DOGGER BANK  
TEESSIDE A & B

# Deadline IV Appendix 19 Appendix D Amended Onshore Works Plan Sheets 5 & 6

**Deadline IV Appendix 19, Appendix E  
Supplementary Environmental Impact  
Assessment Information in support of  
Proposed Order Limits Realignment  
at Plots 58B and 58F**

**DRAWING TITLE**  
**Onshore Works Plan Amendment Sheet 05**

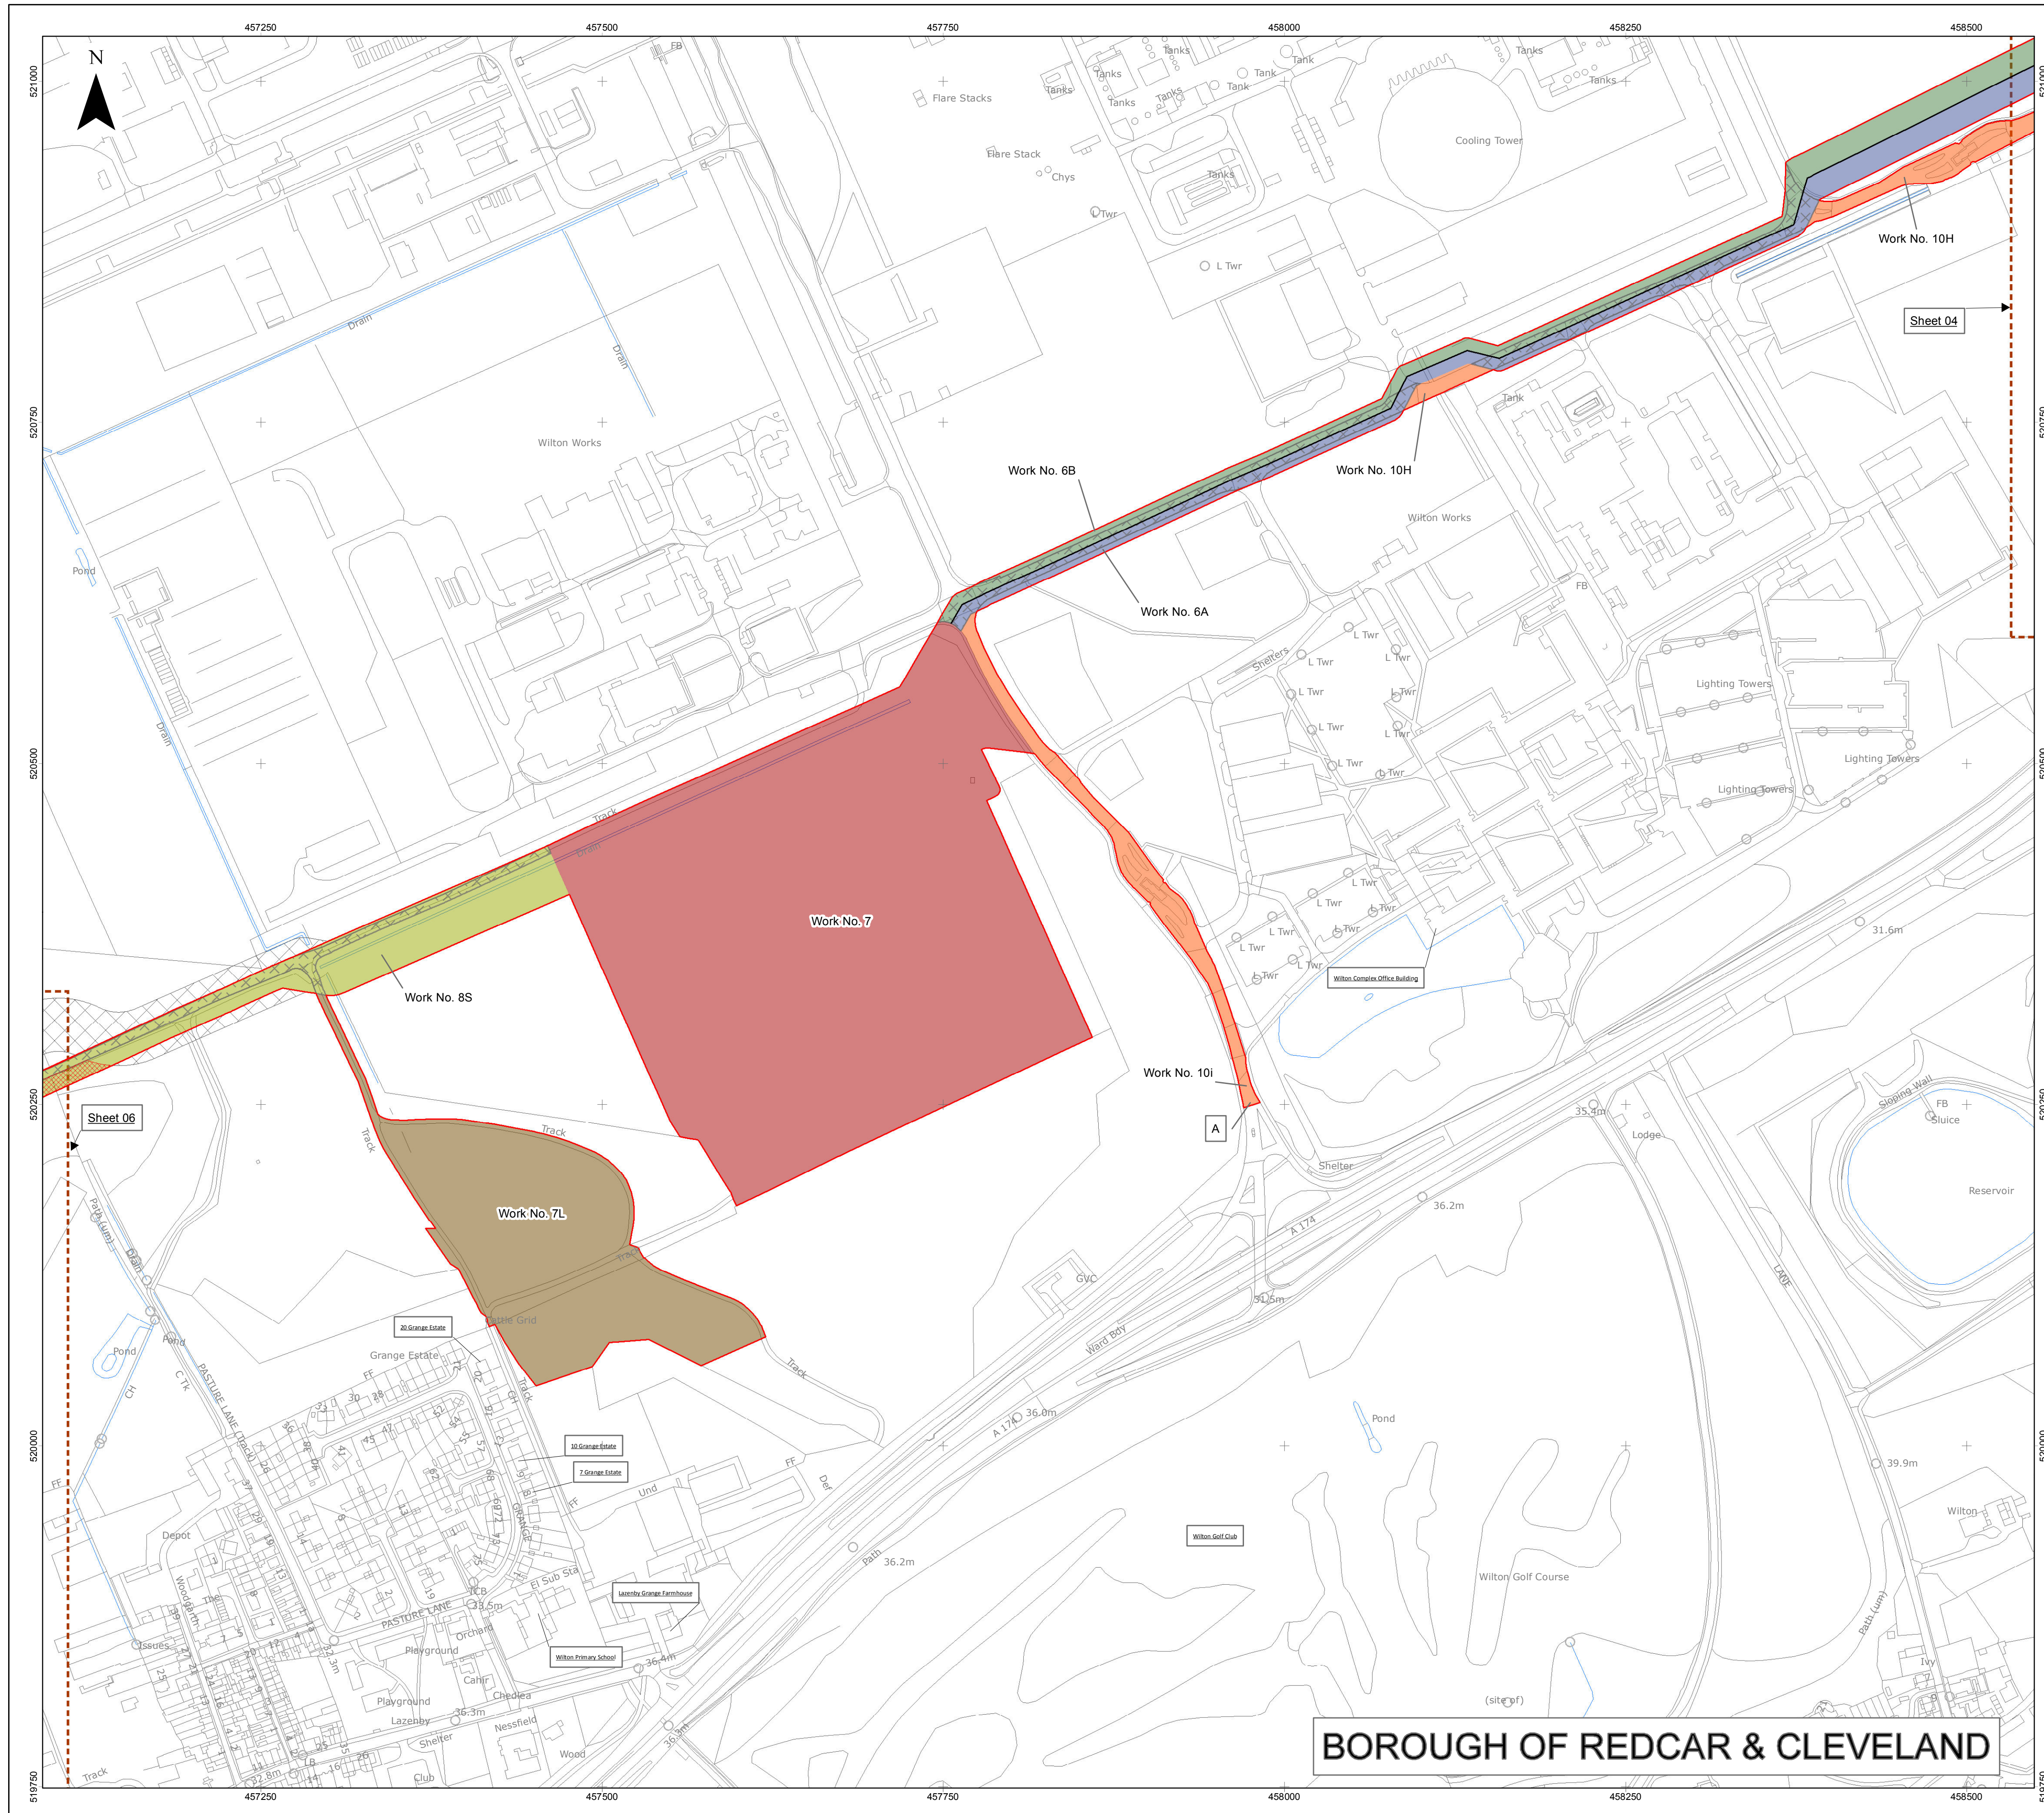
**NOTE: This is an amended sheet submitted to the examination following the amendment to Work No. 6A, 6B, 8A and 8B**

VERSION	DATE	REMARKS	Drawn	Checked
1	20/03/2014	First issue	JR	AG
2	22/09/2014	Updated order limits, Work 6&8	JR	AG

**DRAWING TITLE**  
**Onshore Works Plan Amendment Sheet 06**

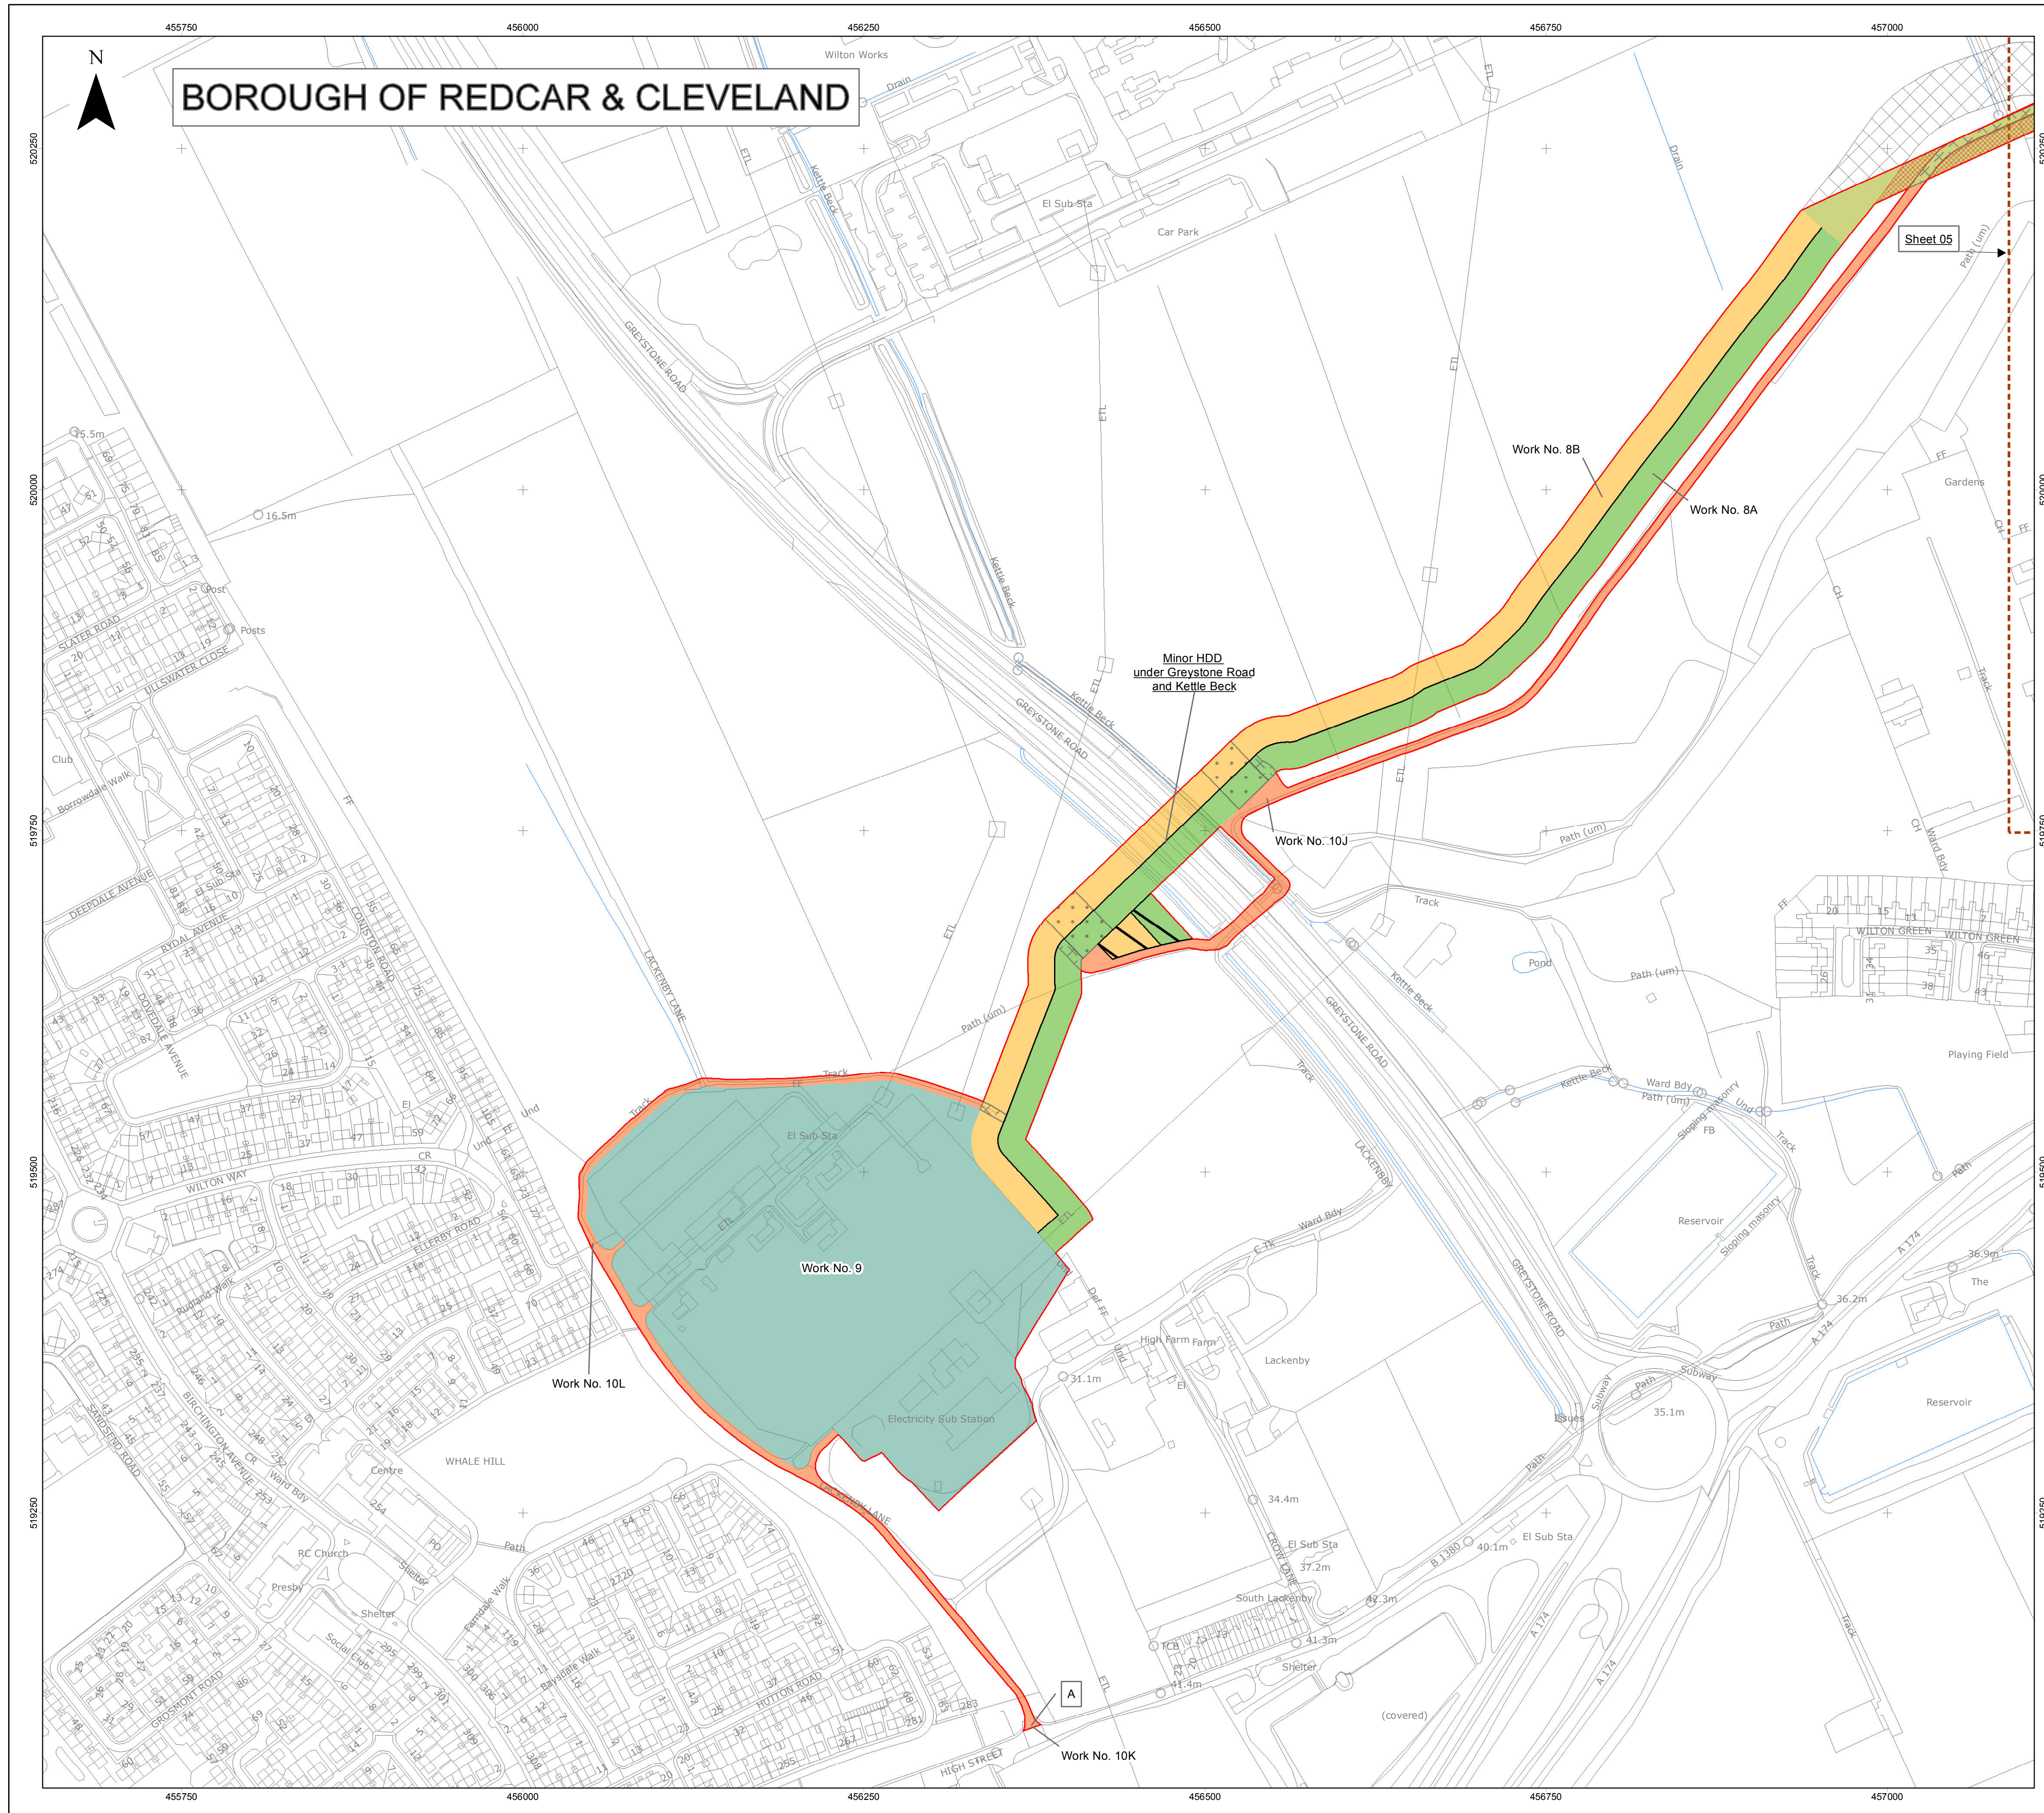
**NOTE: This is an amended sheet submitted to the examination following the amendment to Work No. 6A, 6B, 8A and 8B**

VERSION	DATE	REMARKS	Drawn	Checked
1	20/03/2014	First issue	JR	AG
2	22/09/2014	Updated order limits, Work 6&8	JR	AG

DRAWING TITLE  
**Figure 1 - Dogger Bank Teesside A&B Indicative Onshore Cable Route EIA Addendum**

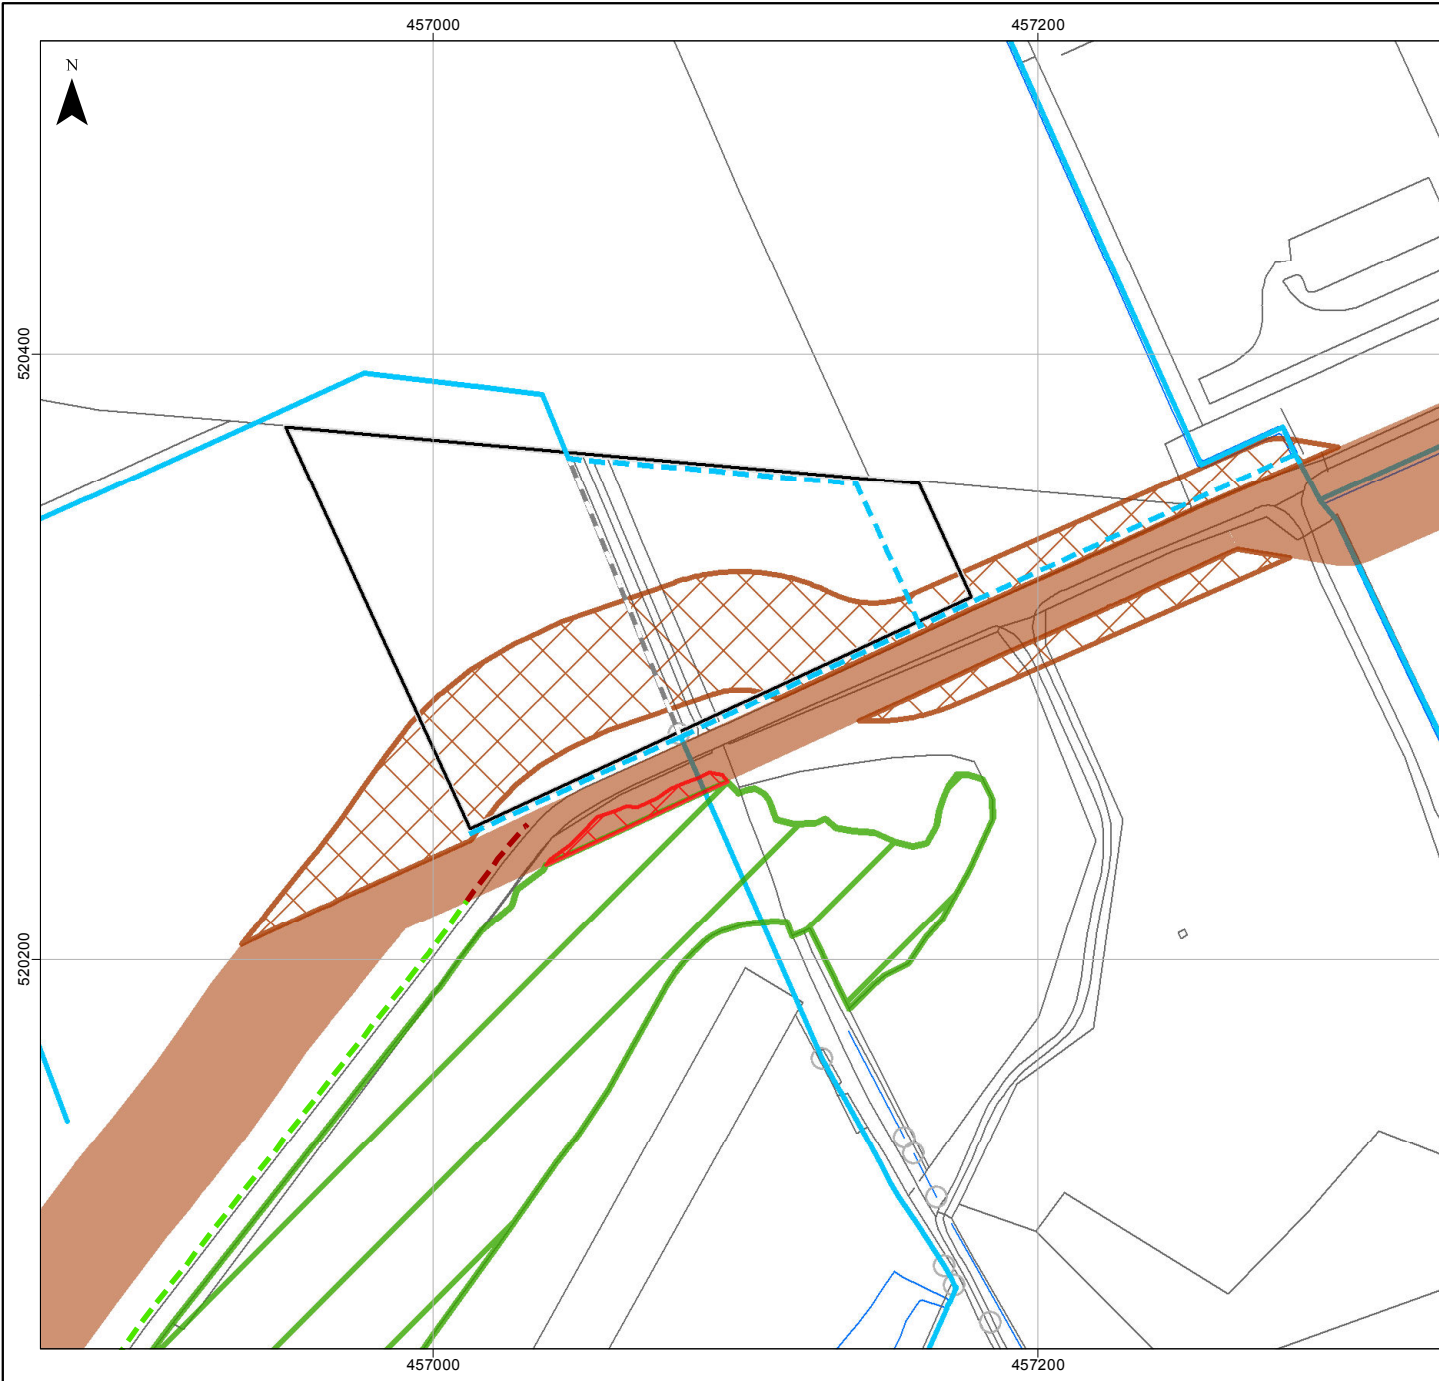
The proposed length of realignment is shown on **Figure 1** and details of the proposed changes, with specific reference to onshore environmental topics, are provided in Section 2.2.

- 2.2.1. The proposed realignment of the HVAC cable route will result in the following changes to the project:
- Approximately 180m length of the HVAC cable route (west of the proposed converter stations) will be realigned to a position approximately 50m south-east of the original alignment (refer to **Figure 1**).

- Removal of approximately 0.03ha of woodland/scrub from an earth bund located to the south of the grain storage facility (refer to **Figure 1**).
- Removal of approximately 0.015ha (30m x 5m) of hedgerow comprising woodland/scrub, located to the north side of an existing track (south of the grain storage facility) (refer to **Figure 1**).

- Relocation of a crossing point associated with an existing drainage ditch to the south of GrainCo Limited's site. No change is required to the crossing methodology as presented in Section 6.3 of Chapter 24, Geology, Water Resources and Land Quality of the ES (application ref 6.24). The relocated crossing point will now be located approximately 50m south-east of the previously identified crossing point (refer to **Figure 1**).

2.2.2. Outside of the order limits of Dogger Bank Teesside A and B, there is a section of ditch that ran through the GrainCo Limited site and has now been re-routed by GrainCo Limited along the southern boundary of their site. The re-routed section of ditch is shown on **Figure 1** and is outside of the order limits of the Dogger Bank Teesside A and B, and will be unaffected by construction of the HVAC cable route.
